Consultant Notes from Public Meeting - First Settlement

From: [Jason Tish](#)
To: [Jennifer Lehrke](#)
Cc: [Scanlon, Amy](#); [Fruhling, William](#)
Subject: HPP – Round 3 HD meeting, First Settlement – Dec. 13, 2018
Date: Thursday, December 13, 2018 6:55:47 PM

Historic Preservation Project

Recommendations for the Standards for Review for Alterations

Figure 1: The Dowling Building and the Lake Park Apartments on West Wilson Street.

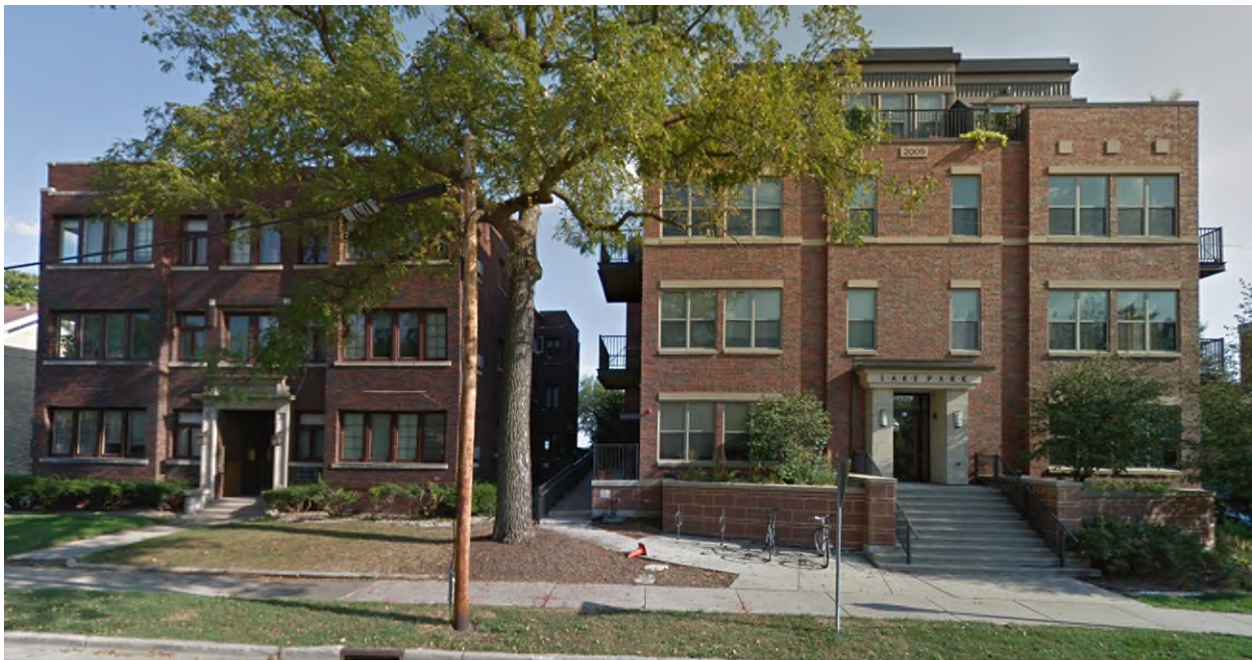
- Page 22, 7th bullet point: The requirement for infill structures to be compatible with the size and scale of surrounding buildings should be clarified so it does not limit structures that are larger than existing buildings. New structures can be built to be visually compatible with existing buildings while allowing a larger square footage (*e.g.*, Lake Park Apartments next to the Dowling Building on West Wilson Street—see Figure 1).
